## **Addendum to EIR**

### **University Villages – Village Three North and a Portion of Village Four**

**PROJECT NAME:** University Villages EIR 13-01; SCH No. 2013071077 – Village Three North and a Portion of Village Four

**DATE:** September 19, 2016

**FIGURE 4**  
**Proposed Project Site Utilization Plan**

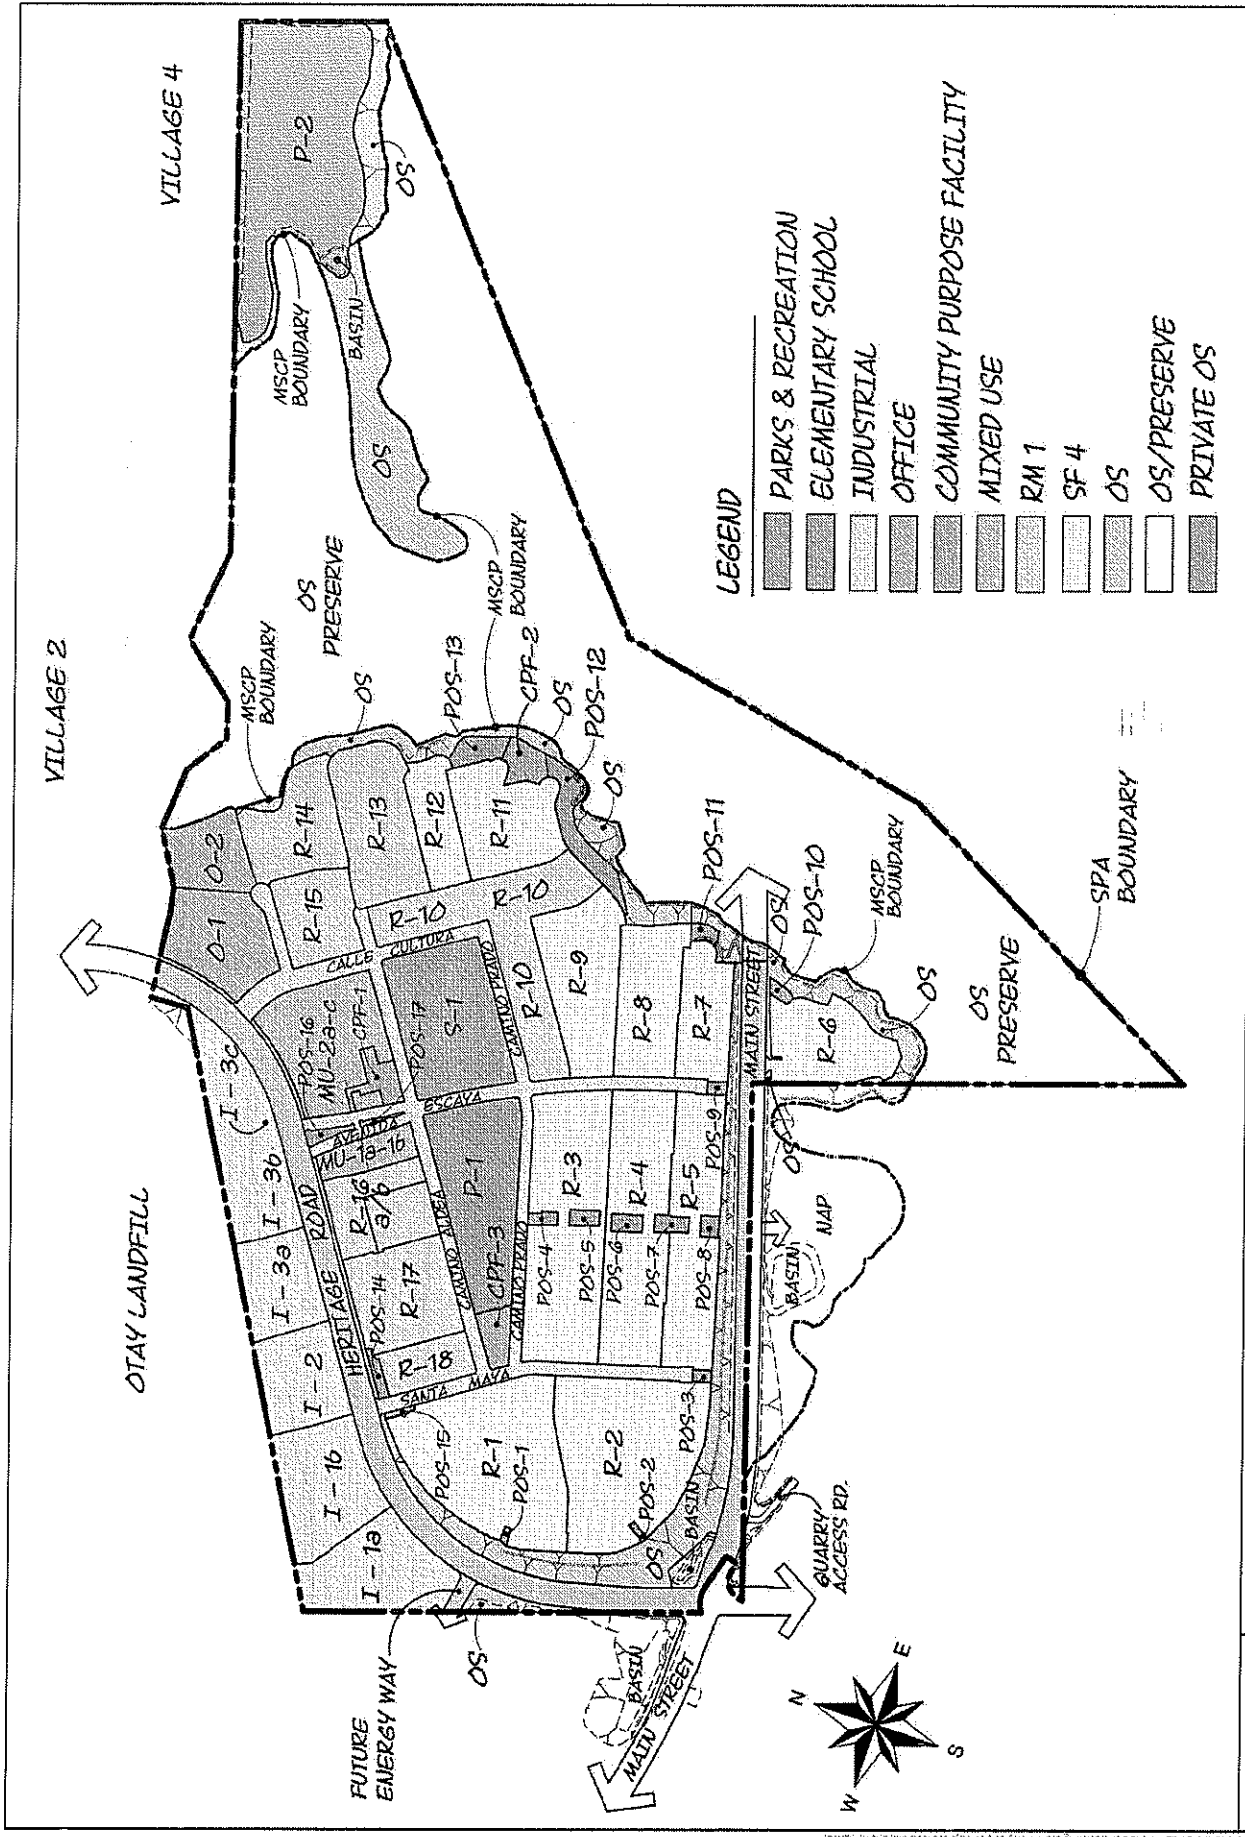
The approved land use plan for Village Three North and a Portion of Village Four would allow for the construction of 1,002 single-family units, 515 multiple-family units, and 80 mixed-use units; 8.3 acres for a school; 29.3 acres of industrial land use; 4.3 acres of Community-Purpose Facilities (CPF); 8.3 acres of office; 25.9 acres of parkland; and 34.8 acres of open space (Figure 3). There would be no proposed changes to the Portion of Village Four. The proposed modifications to the approved project are as follows (see Figure 4):

- Maintain 1,002 single-family and 595 multiple-family, 1,597 dwelling units in total, as previously approved within Village Three North.
- Update the SPA Site Utilization Plan and Table to reflect the revised land use plan, internal streets, neighborhood boundaries, and unit allocation by neighborhood.
- Revise the single-family lotting pattern to include the following new lot sizes/products:
  - 50 × 90 feet
  - 55 × 90 feet
  - Detached courtyard
- Establish a multiple-family neighborhood (R-16) adjacent to the Mixed Use (MU)-1 parcel.

- Provide a north-south meandering paseo, designated Private Open Space (POS) 4-8, through the single-family neighborhoods, providing a strong pedestrian connection to the elementary school, public neighborhood park, and village core

- Assign 198 multiple-family units to the MU-2 parcel for a total of 278 multiple-family units within the MU-1 and MU-2 parcels
- Reconfigure the P-1 Neighborhood Park

- Relocate the Community Purpose Facility (CPF)-3 site adjacent to the P-1 Park
- Modify the central entry street (Avenida Escaya) through the MU area to create a strong sense of arrival and activity within the corridor, while providing a grand landscaped median (“Village Green”) and enhancing the viability of the retail and commercial spaces fronting the street

- Realign the residential street at the southeastern corner of Village Three North and designate a Private Open Space (POS) at the project perimeter
- Provide an additional 3 2-acre Office (O) parcel (O-2) east of the O-1 site

- Reconfigure the Village Three North Water Quality/Hydromodification basins to include three basins: one on-site 0.6-acre basin at the southwest corner of Village Three North and two off-site basins, including a 3.9-acre basin north of Main Street and west of Heritage Road (former Takashima property) and a 1.75-acre Water Quality/Hydromodification basin within Village Three South to the south of Main Street (Flat Rock property)

- Eliminate two Industrial Street cul-de-sacs within the Industrial area north of Heritage Road, provide driveway entries to the Industrial area and update the Industrial acreage
